Summary	Plexline Upgrade			
Products Affected	Plexline			
Key Word Tags	Drum, Upgrade, Bolt Replacement, Shaft			
Tools/Equipment (If Required)	Man lift/Ladder 8mm Allen wrench and ratcheting wrenches (have extras in case they break) The Allen wrench will need to be cut to a length of 1 ½" (Keep extras on hand in case they get lost) 13/16" Deep Socket for leverage or small breaker pipe			
Parts/Materials (If Required)	Hardware Kit supplied by Rytec (4 bolts)			
Related Media				
Author	Jeff Miller	Issue Date	2-7-14	Status Active

Please Read The Entire Bulletin Before Proceeding

View is with front motor cover removed

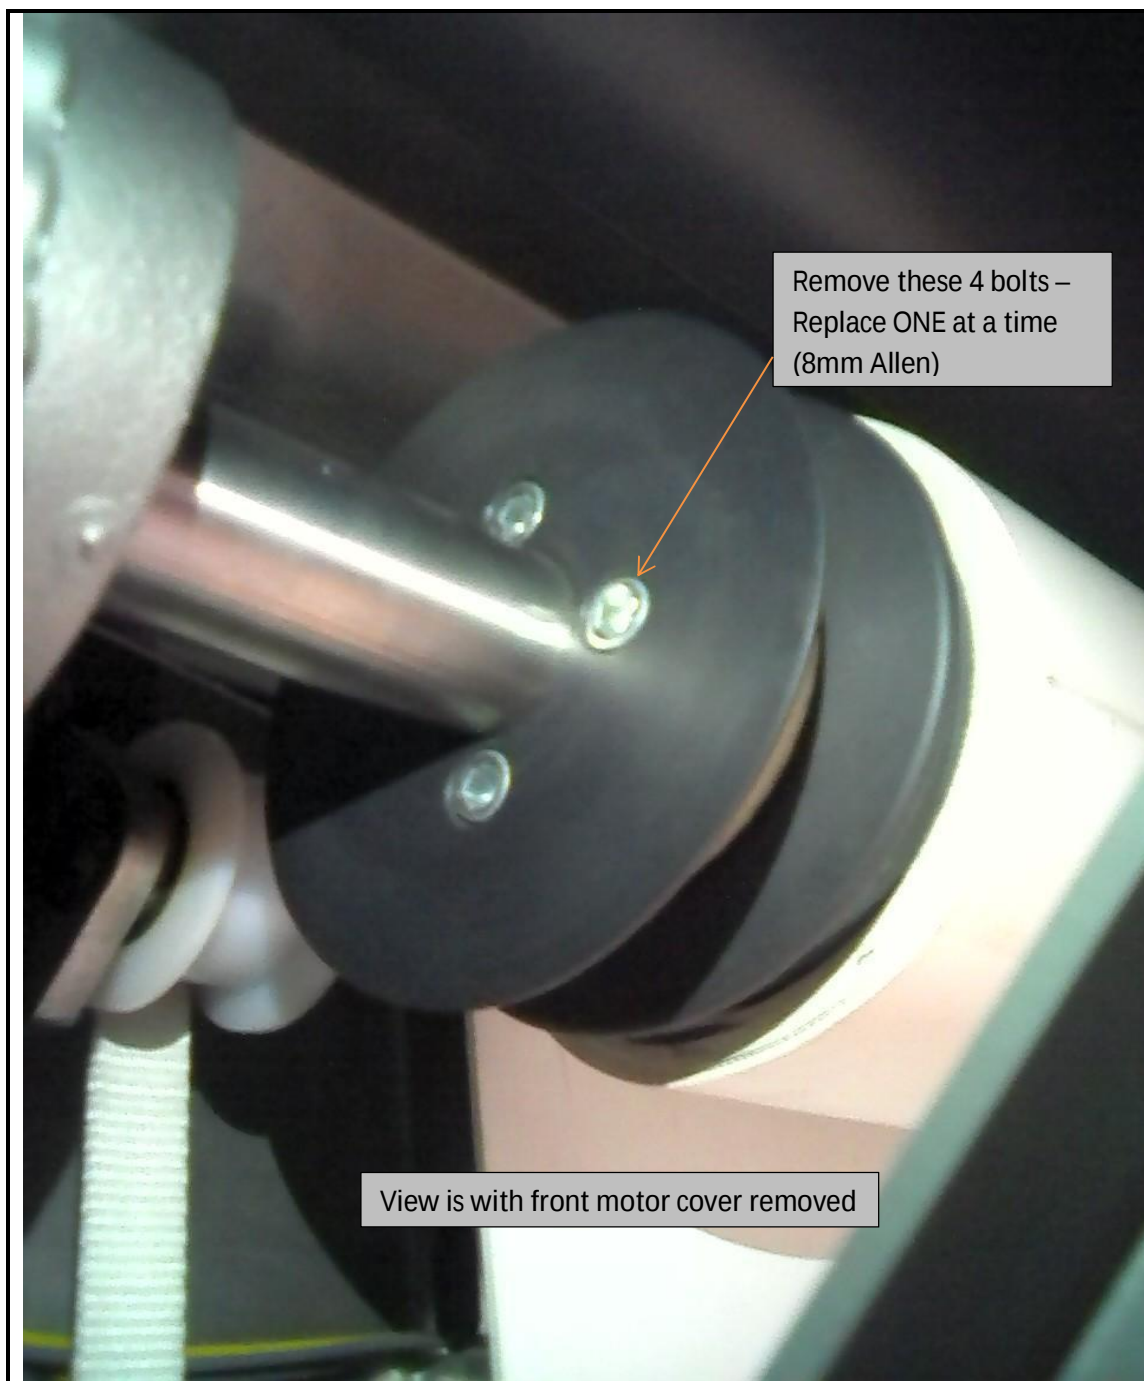
Using a man lift or ladder, go up to the motor. Locate where the drum shaft is connected to the motor and the drum. On counterweighted doors there will be a pulley with 4 bolts that go through to the drum. These are the bolts you will change out. Doors without counterweights will have 4 tapped holes on the drum.

Remove these 4 bolts –
Replace ONE at a time
(8mm Allen)

ONE at time, remove each bolt (if any) and replace it with the supplied hardware, Loctite and tighten. It may be necessary to rotate the drum in emergency jog slowly to get at all 4 of the bolts. If there is no pulley, add the new bolts to the tapped holes on the drum and tighten them.
